**TEMPLEOGUE / RATHFARNHAM TO CITY CENTRE CORE BUS
CORRIDOR SCHEME**

SDCC SUBMISSION:

SID PLANNING APPLICATION TO AN BORD PLEANÁLA:

Date: March 2024

Figure 4 Photograph No. 1: shows a line of trees located along Rathfarnham Castle Park's western boundary wall at the northern end which have not been included within the survey drawing.

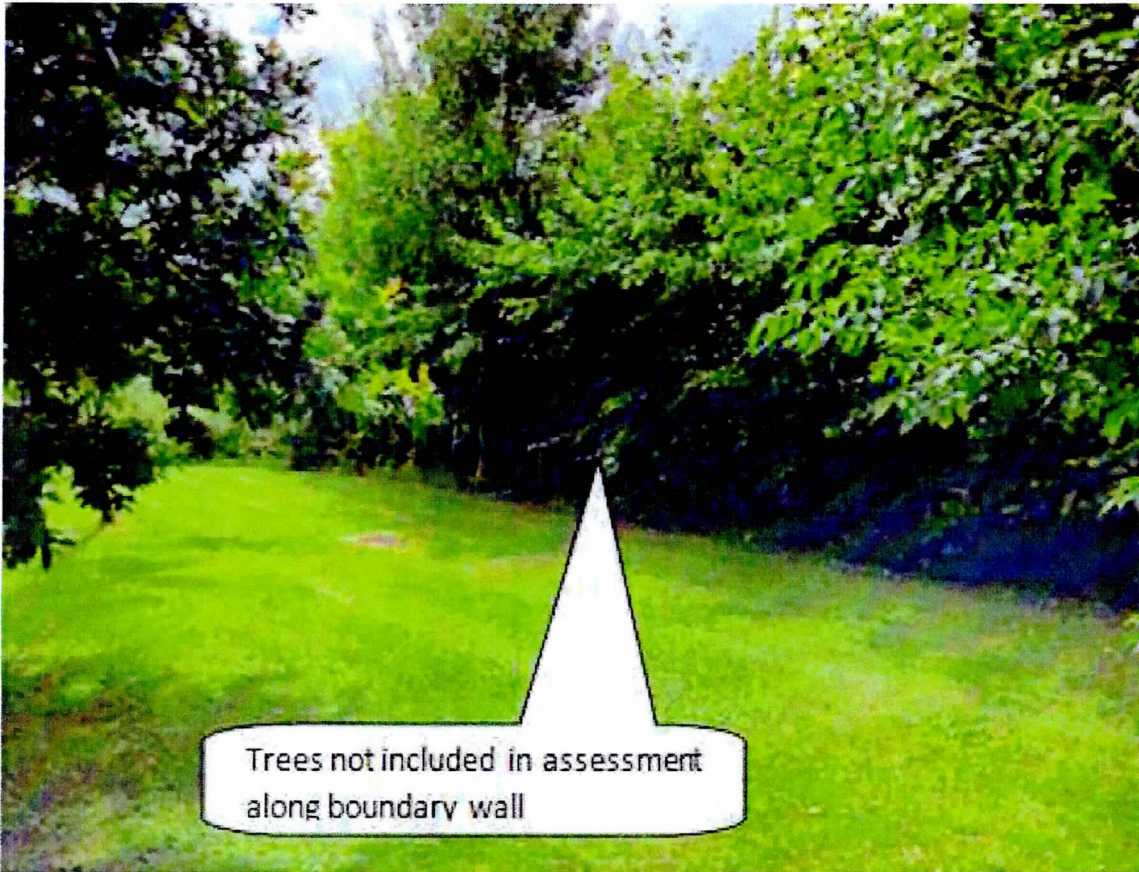
A) With some exceptions the tree survey within Rathfarnham Castle Park has been mainly confined to the land take for the bus connects corridor. There are trees located outside this land take area with root zones that would extend into the site area which have not been mapped or surveyed. Therefore, the impact of proposed works on these trees has not been fully considered or included in the overall impact assessment. Photograph No. 1 (Figure 4 below) shows existing trees that are within the proposed site boundary which do not feature on the survey mapping.

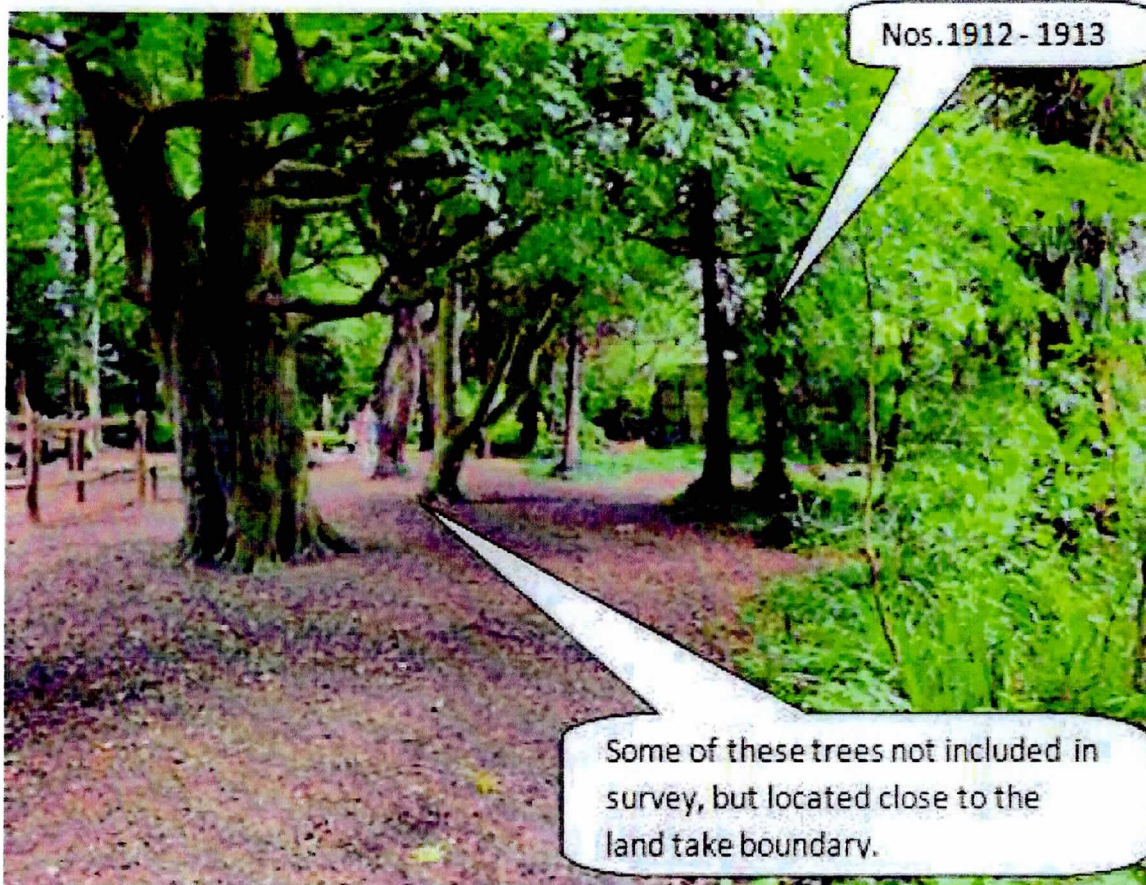
Figure 5 Photograph No. 2: some of these large size trees are located outside the land take, but would have root zone calculations which would extend into the land take area with possible implications on the health of these trees. Some of these trees have not been picked up on the tree survey or plotted on the topographical survey.

Figure 11 Construction Compound TR3

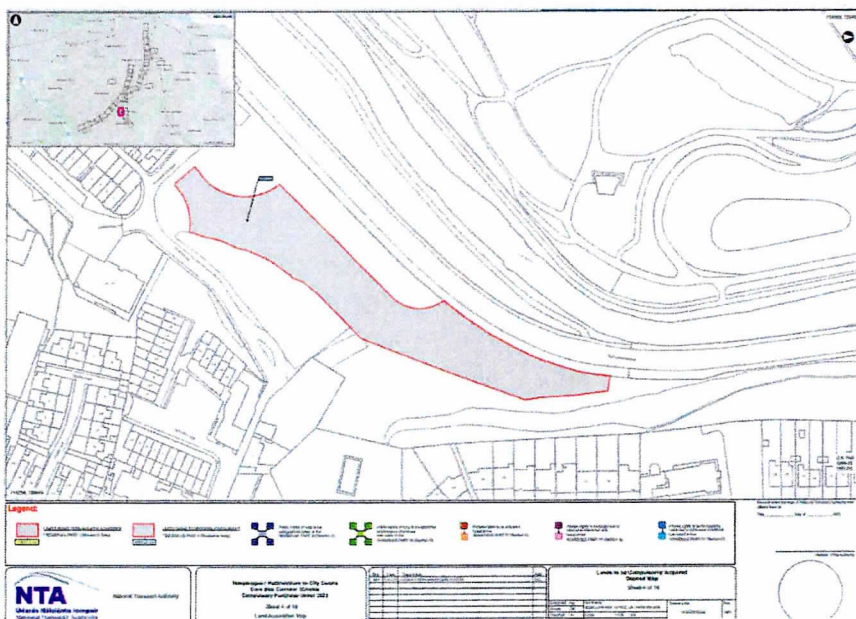
- **Construction Compound TR3:** To be located along Dodder View Road, in the open space area between Dodder View Road, Woodview Cottages and Church Lane. Site extents are limited to avoid any direct impacts on existing trees. (off-chainage). See Figure 11 below:

The proposed compound location above is in the Dodder Valley and is close to the site of an existing term-limited, temporary construction compound where SDCC have agreements regarding full reinstatement of the compound area to planted, landscaped parkland. The above shown extent is excessive and occupies the majority of the usable parkland at this location. SDCC public realm do not recommend ceding of this important location with a temporary CPO. SDCC recommend that the extent of the proposed compound should be limited to the existing compound location on site, and the extent, mitigation and reinstatement measures are to be agreed with SDCC public realm section by local agreement rather than CPO.

Figure 12 Construction Compound TR6

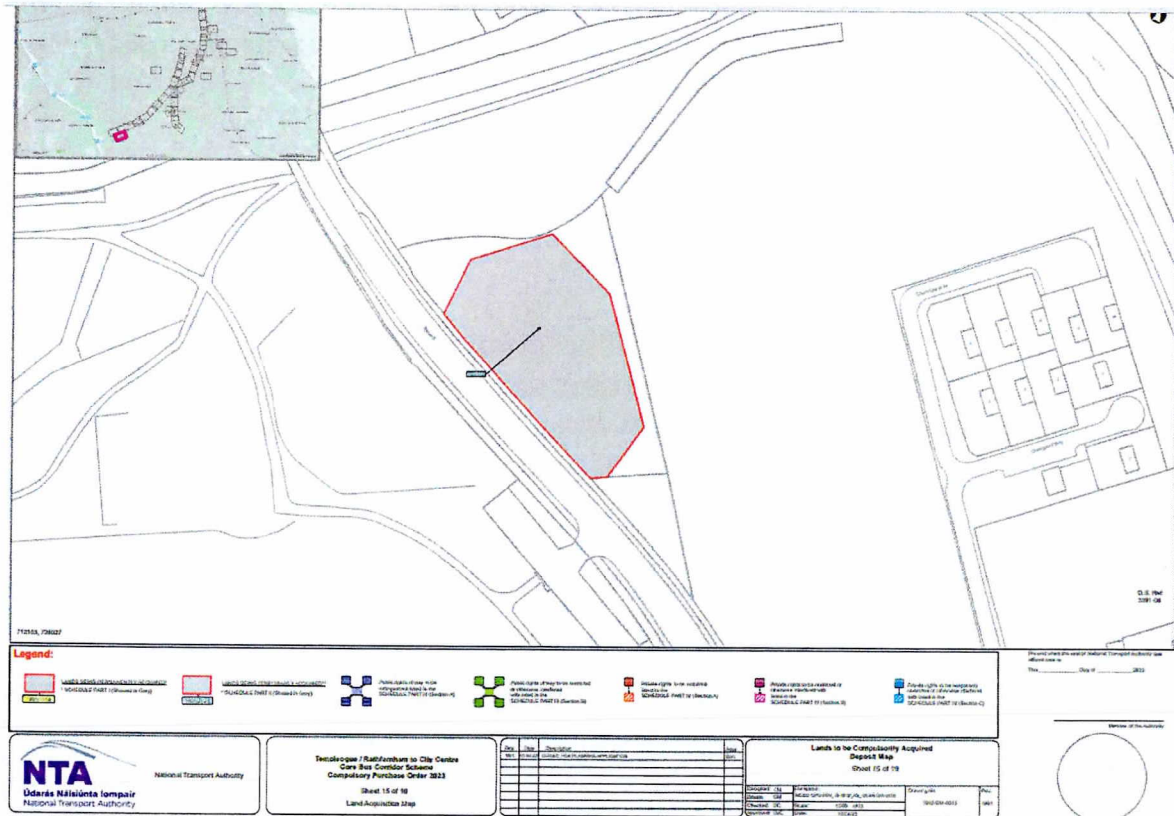
- Construction Compound TR6: To be located on Spawell Link Road, between Spawell Roundabout and Firhouse Road (off-chainage). See Figure 12 below:

This location is in the Dodder Valley and is the site of an existing term limited and temporary construction compound where SDCC have agreements regarding full reinstatement of the compound area to planted, landscaped parkland. SDCC public realm do not recommend ceding of this important location with a temporary CPO. SDCC recommend that the extent, mitigation and reinstatement measures are to be agreed with SDCC public realm section by local agreement rather than CPO.

Figure 13 Junction of Grange Road with Nutgrove Avenue

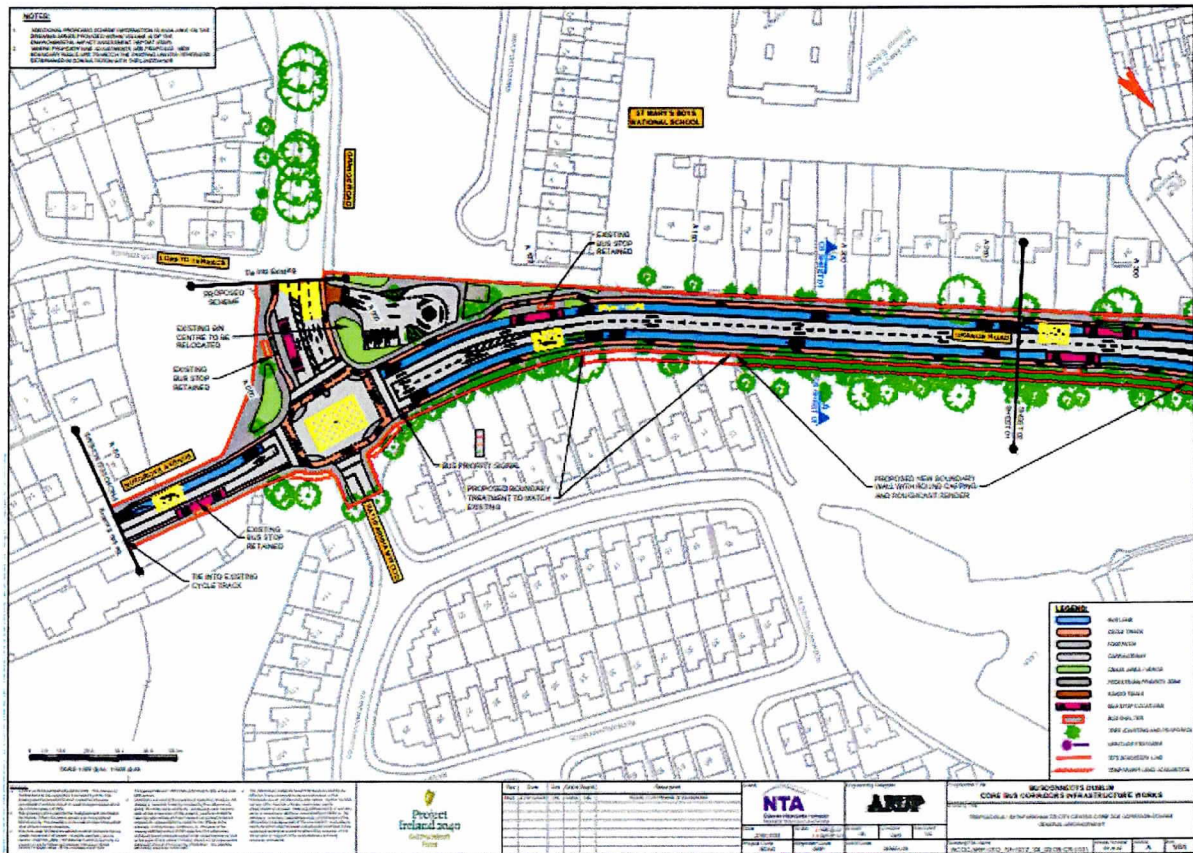
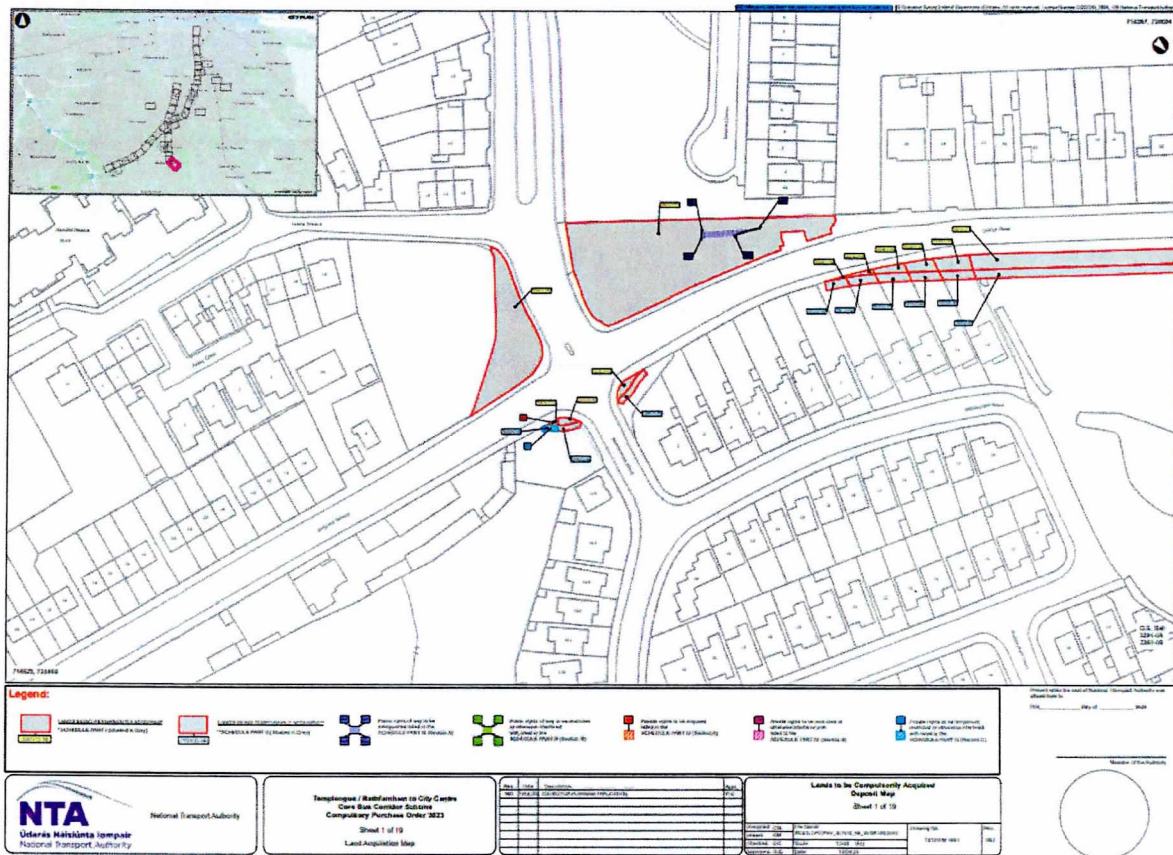
SDCC has recently upgraded the car park at this location to the south-west of the junction.

There are a number of CPOs at this junction above, with a proposal to permanently CPO the lands either side of the south side of the junction. It is unclear why this is required; as the areas in question do not appear within the general arrangement or landscape drawing having any permanent NTA related proposals.

Figure 15 CPO

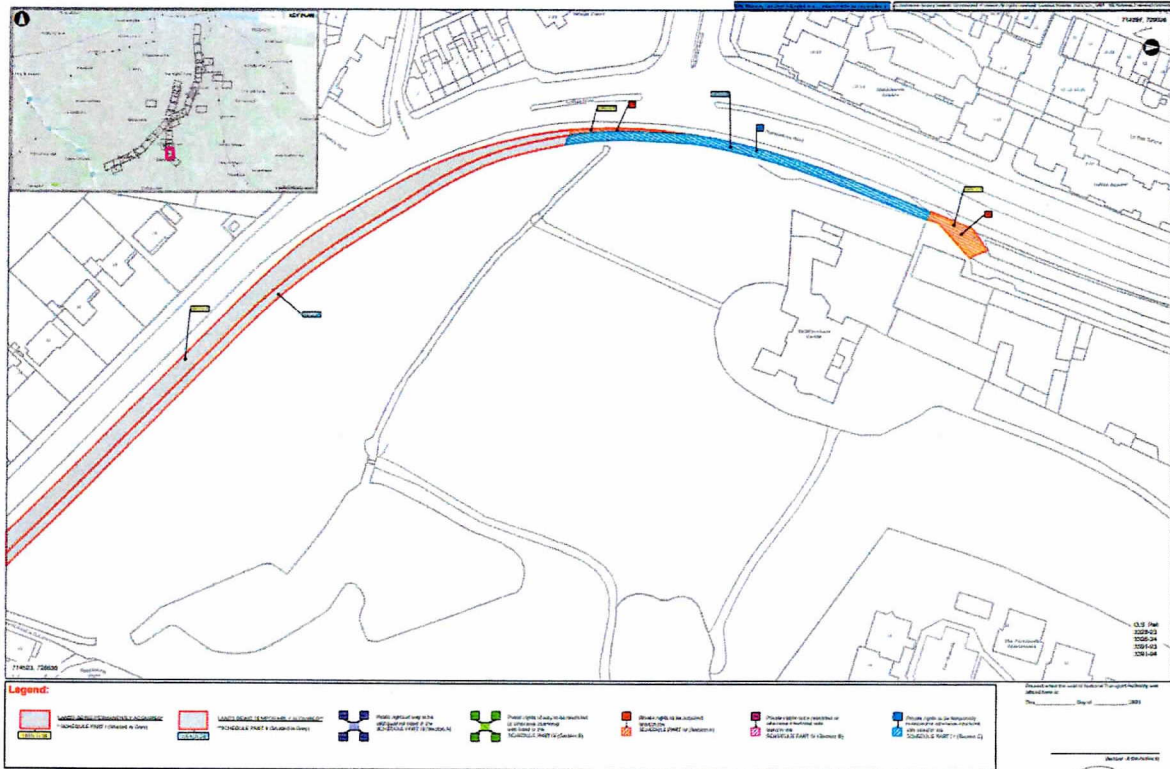
The earlier part of this report documented the significant impact on existing trees at this location, but the loss of parkland and amenity should also be fully considered. There is a significant proposed loss of public parkland at this location with a permanent change of parkland to vehicular carriageway; with little in terms of proposed mitigation:

There is also a proposed temporary CPO of land to build the works impacting on Rathfarnham Castle Park.

Figure 16 CPO

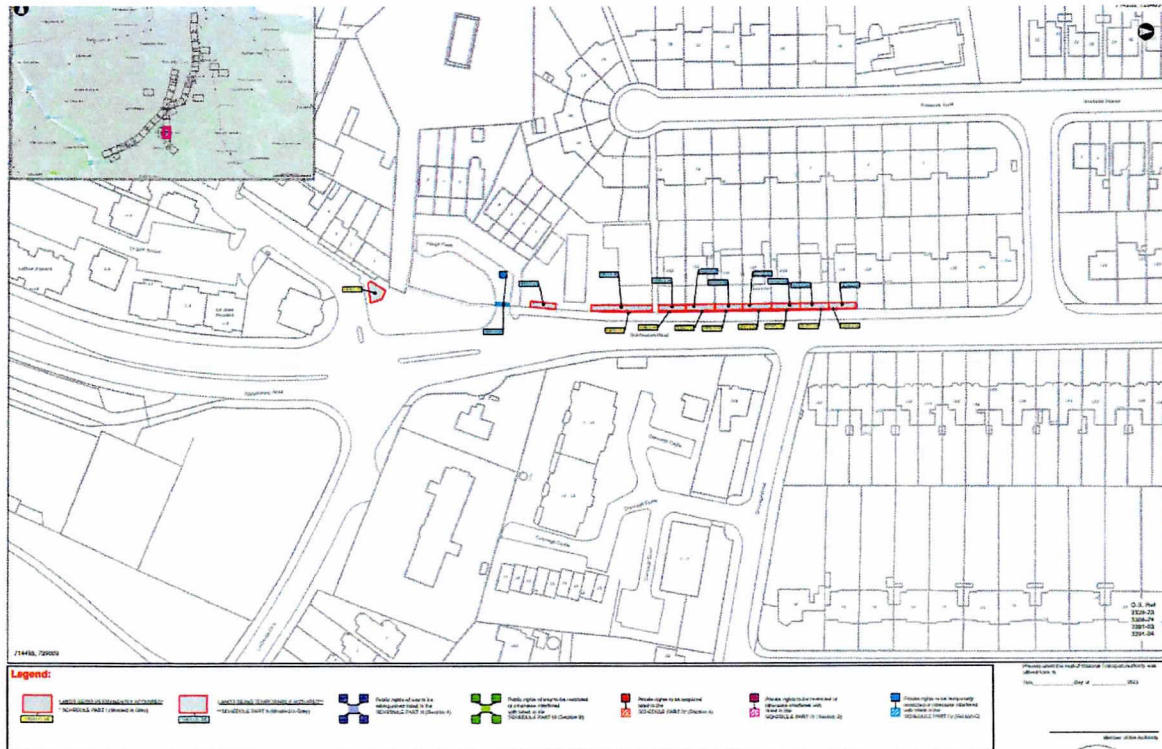
SDCC public realm are unsure why there is a permanent CPO proposed the junction of Rathfarnham Main Street and Rathfarnham Road shown above, the CPO is located in a section of the plaza at the old Graveyard entrance. There does not seem to be any relevant proposals in the general arrangement drawing for this area that require a CPO. This is the access route for maintenance to the historic graveyard and is used by local traders for on-street display. There does not seem to be any requirement for the NTA to CPO this land.

This plaza area was improved during a recent village improvement scheme, a number of these relatively recent interventions will be affected by the proposal including the removal of newly planted trees. This scheme does not include a compensatory landscape layout for the area and ABP are requested to consider applying a condition for the NTA to agree with SDCC Public Realm and Roads Maintenance Depts a landscape proposal for this area to provide replacement trees, incorporation of natural SuDS and other landscape interventions at this high profile location at the entrance to Rathfarnham Village.

Figure 17 CPO

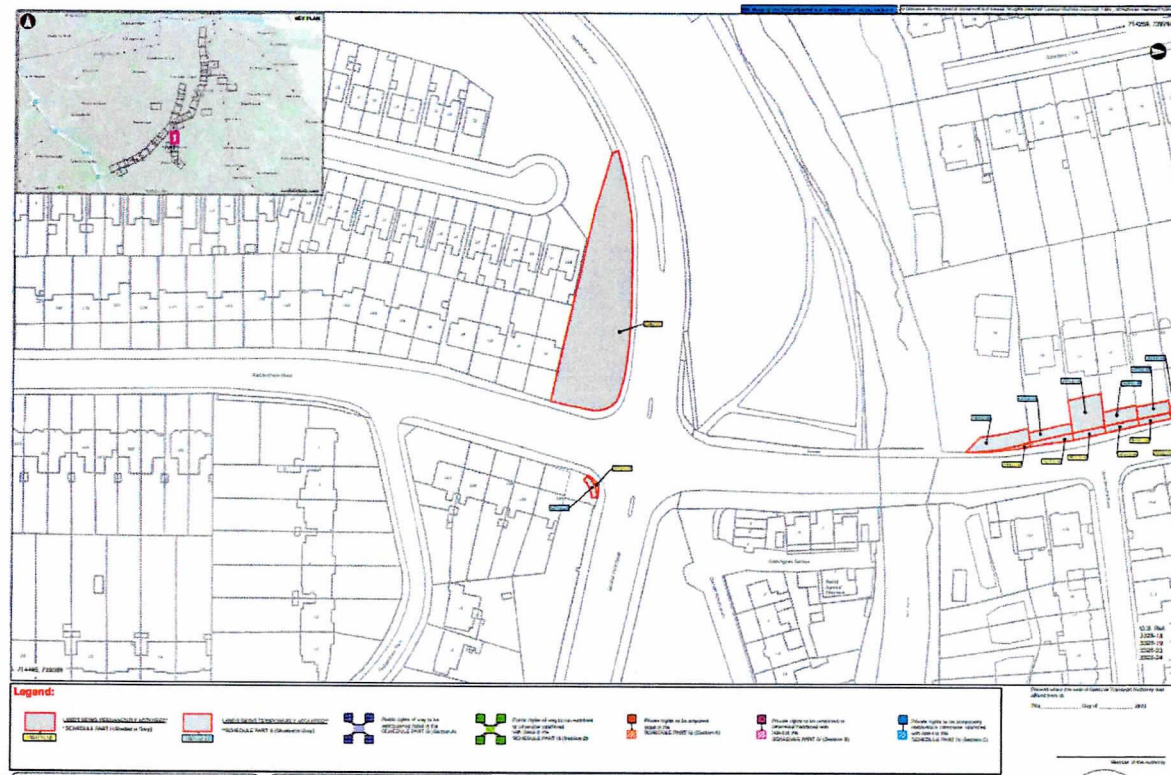
Dodder Greenway tie-in at Pearse Bridge. Drawing No. 1012-DM-0005 Rev M01. CPO reference 1068 (1).1f.

SDCC note the extent of permanent CPO at Pearse Bridge location to the south-west of the junction above. The proposal for a permanent CPO at this location is extensive and excessive. There are no proposals on the landscape plan nor in the general arrangement plan that would require NTA to be in control of these lands for any purpose whatsoever. SDCC Public Realm have not been made aware of any requirement for the use of these lands by the NTA.

Figure shows Tree No.1919 positioning on the drawing and its actual position on the ground. Photograph shows the tag No.1919 on the tree with the boundary wall next to this tree.

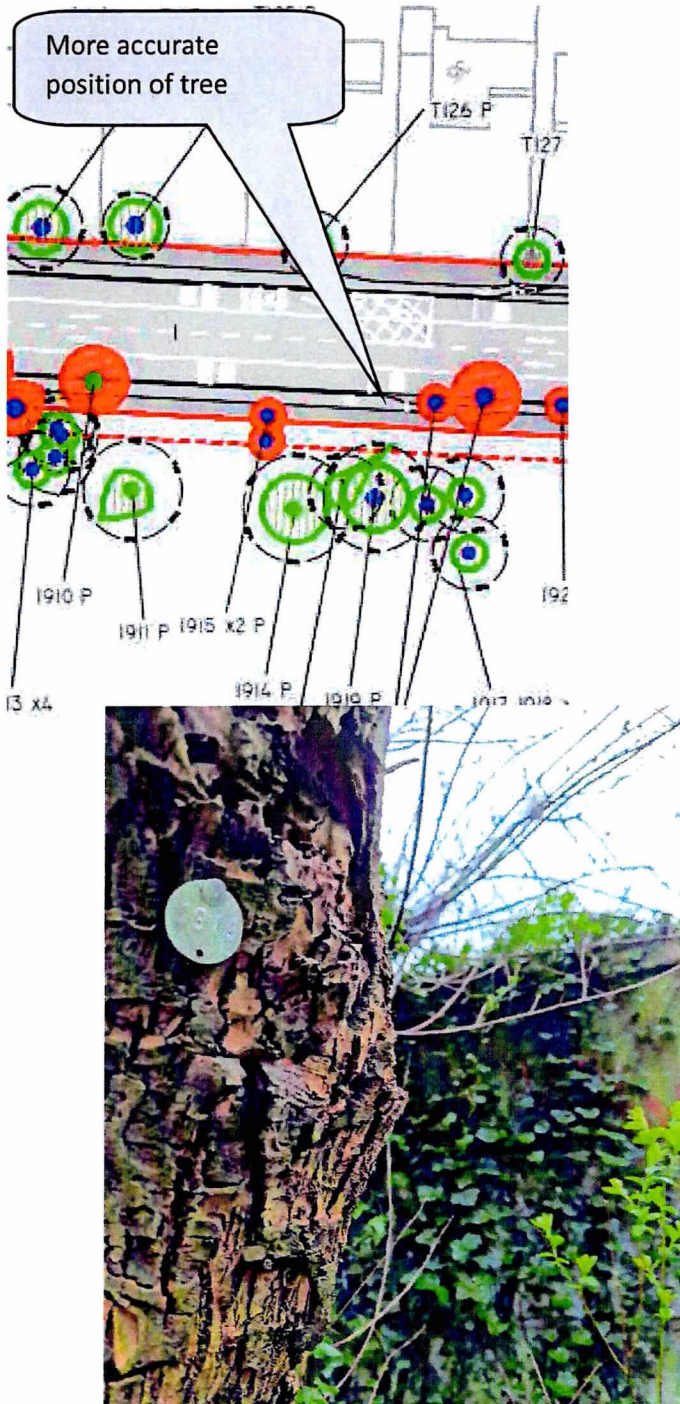
- B) SDCC notes that the topographical survey does not seem to reflect the accurate position of existing trees. SDCC notes that there are some trees shown for removal which could in reality be retained, and some trees shown for retention which in reality will require removal. SDCC provided an example, Tree No. 1919 which is located within the permanent land take boundary but is shown on the drawings as being further back and to be retained.

Reply: I have reviewed this and would concur with SDCC that there are areas where the positioning of trees would not appear to be fully accurate. The assessment of this is difficult as we are reviewing this using PDF drawings, but there are trees that are obviously not in the right position such as the example given by SDCC of Tree No.1919 which is growing against the base of the boundary wall, but on the survey drawings it is shown well in from the boundary wall and shown for retention when in fact due to its proximity to the boundary wall and land take necessary for the proposed scheme, this tree will need to be removed. I have checked the position of this tree on site and confirm that it is located against the inside of the boundary wall and not as shown on the survey drawings.
